# 1997 - 2002 Corvette: Service Bulletin: Door Rattle with Moderate to High Audio System Volume

**Number:** 01-08-64-009A

**Date:** 06-19-2002

**Model Year:** 1997-2002 Chevrolet Corvette

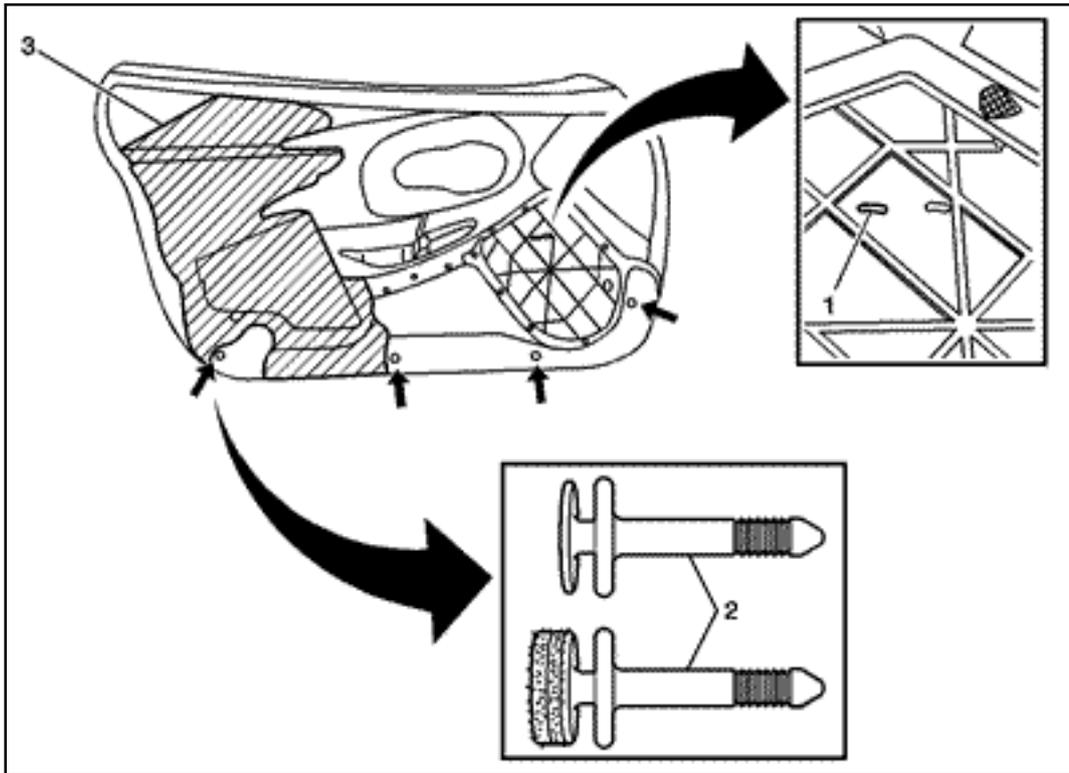
**Change implemented in 2002 VIN breakpoint 125078. Vehicles built prior to this breakpoint will require the following procedure.**

New speaker screen is made from a different material and Bose® emblem is provided due to risk of old emblem becoming damaged while removing.

1. Straighten the speaker grille tabs and remove the grille from the door panel.
2. Remove the Bose® emblem from the speaker grille and discard.
3. Remove the speaker screen from the grille and discard.
4. Install the new speaker screen to the grille.
5. Install the new Bose® emblem and carefully crimp the staples (1) to the speaker grille.
6. Insert the speaker grille tabs into the door panel slots and bend the tabs

7. Trim any extra loose door panel leather skin from around the speaker grille area on the back side of the door panel.
8. Repeat above steps for opposite side.

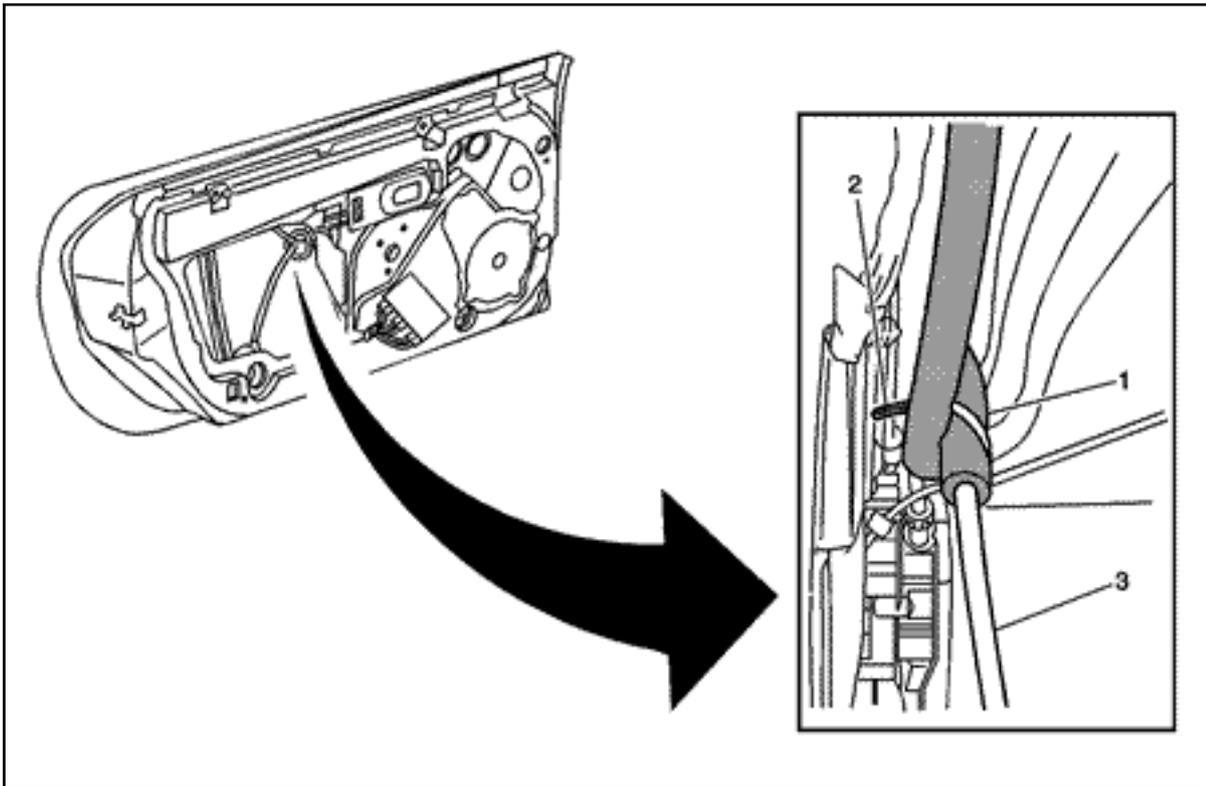
**Change implemented in 2001 VIN breakpoint 115500. Vehicles built prior to this breakpoint will require the following procedure.**

1. Remove the 4 lower door trim panel retainers (2) from both door panels.
2. Cut 16 dime sized coins from the fine side of Velcro®, 3M® P/N 051131-06481, or equivalent.
3. Install 2 Velcro® coins to each of the 8 door trim panel retainers (2).
4. Reinstall the door trim panel retainers (2) into the door trim panels.

**Change implemented in 2000 VIN breakpoint 110900. Vehicles built prior to this breakpoint will require the following procedure.**

1. Only perform the following procedure if the side impact styrofoam (3) is loose from the door panels.
2. Resecure the side impact foam (3) to the door trim panels using 3M® Urethane, P/N 051135-08690, or equivalent.

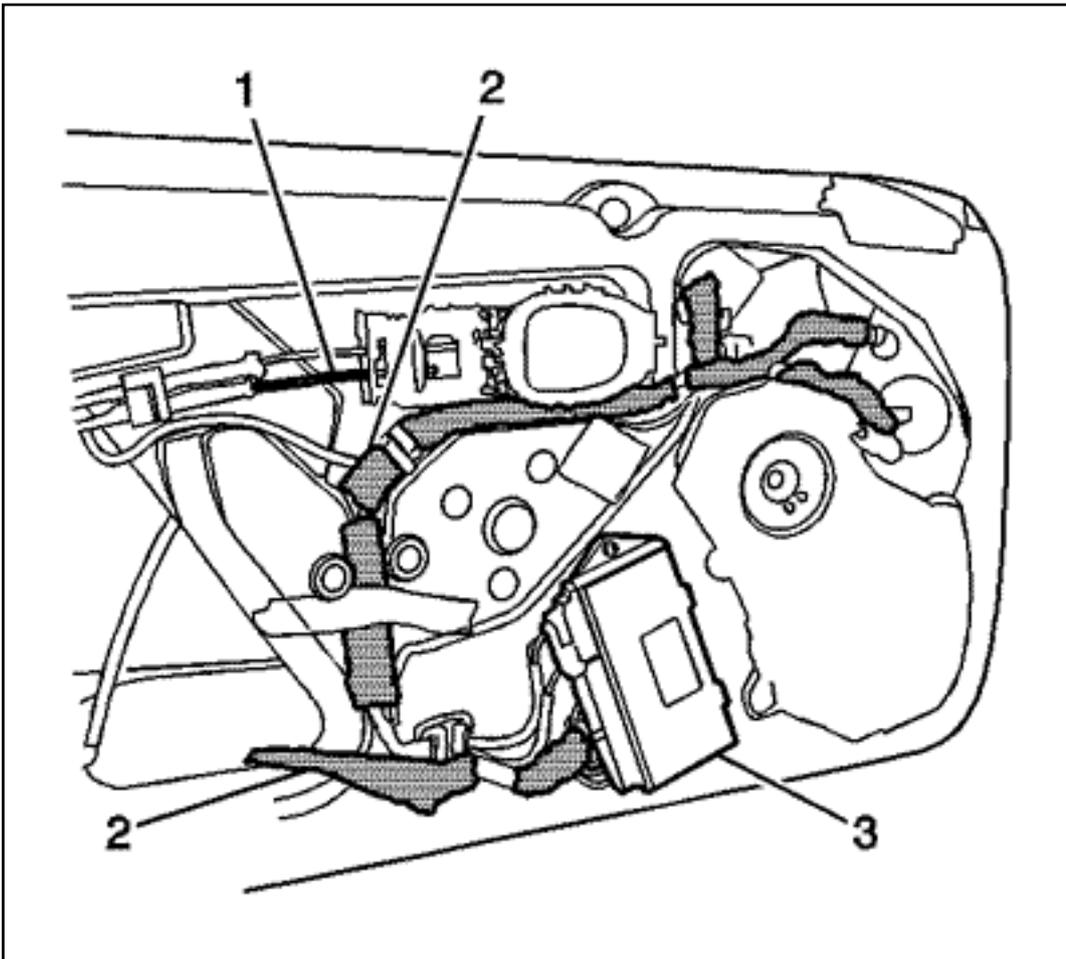
**Change implemented in 1999 VIN breakpoint 133100. Vehicles built prior to this breakpoint will require the following procedure.**

1. Remove the water deflector.

**Do not damage the push-in retainer/tie straps (2). They are to be reused.**

2. Remove the push-in retainer/tie straps (2) that retain the window regulator cables (3) to the inner door panels.
3. Reposition the push-in retainer/tie straps (2) out of the way.
4. Add 122 mm (5 in) of 3M® Open Cell Interior Foam Tape (1), P/N 051131-62385, or equivalent, to the window regulator cables (3) where they contact each other and the inner door panels.

5. Reinstall the push-in retainer/tie straps (2).
6. Reinstall the water deflector.

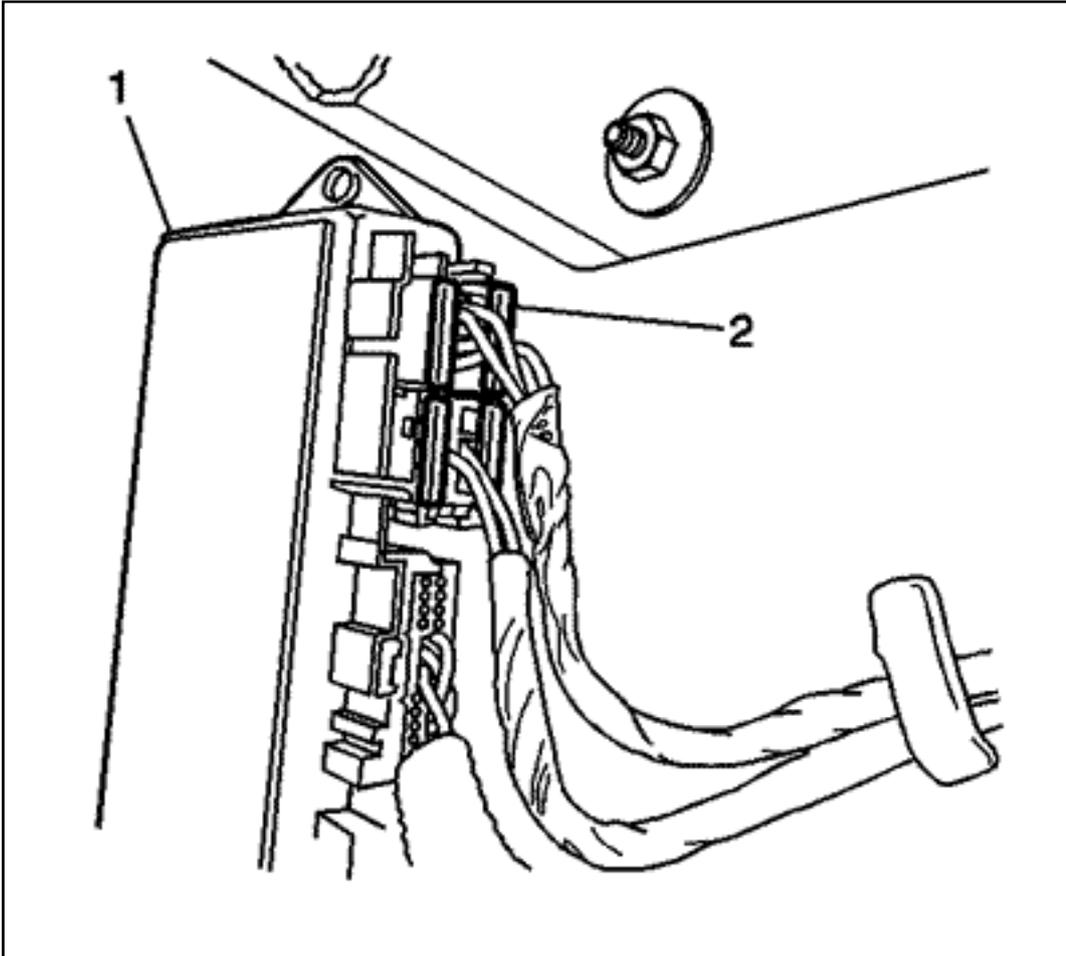
**Change implemented in 2000 VIN breakpoint 101578. Vehicles built prior to this breakpoint will require the following procedure.**

1. Remove the wire harness (2) from its retainers.
2. Insulate the wiring harness and in-line connectors (2) where the wiring harness and the in-line connectors (2) contact the door with 3M® Open Cell Interior Foam Tape (2), P/N 051131-62385, or equivalent. It is best to insulate the entire wiring harness (2).
3. Insulate the right door speaker connector with P/N 12378189.

**Change implemented in 2000 VIN breakpoint 123000. Vehicles built prior to this breakpoint will require the following procedure.**

1. Remove the screws attaching the door control modules (3).
2. Add felt, P/N 12378189, to the backside of the door control modules (3) where it contacts the inner door panels.
3. Position the door control modules (3) to the doors.
4. Install the screws attaching the modules (3). **Tighten**

Tighten the door control modules (3) attaching screws to 3 N·m (27 lb in).

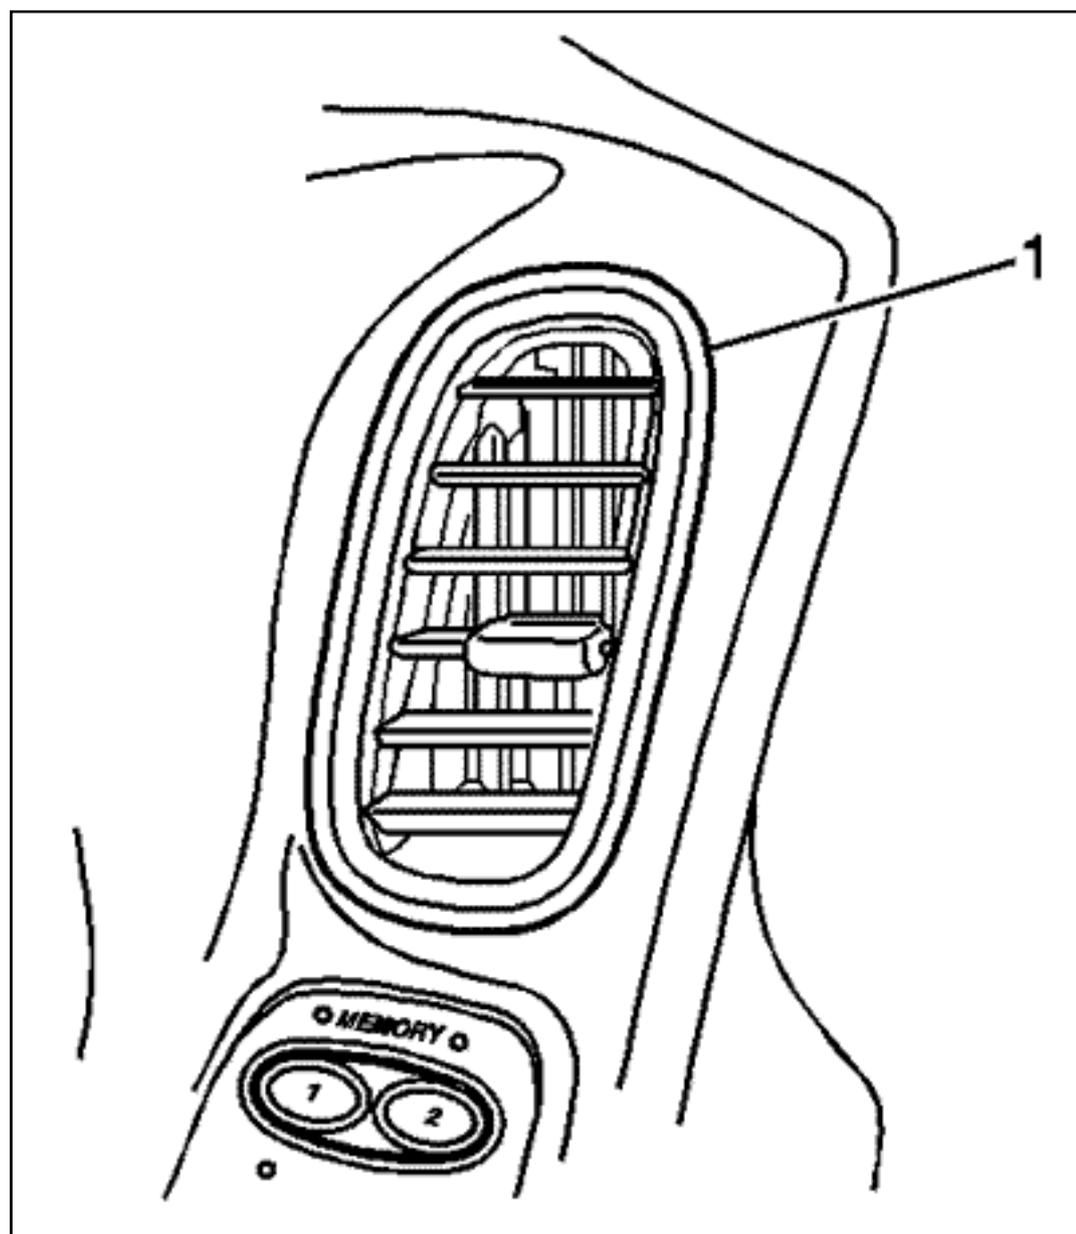
**Change implemented in 2000 VIN breakpoint 120397. Vehicles built prior to this breakpoint will require the following procedure.**

Add a small piece of duct tape, 3M® P/N 051131-06969, or equivalent, to the door control modules (1) terminal positive assurance (TPA)'s (2). They are grey in color and there are a total of 4 TPA's (2) per door. If the TPA's (2) are blue, they are the new design and do not need to be taped.
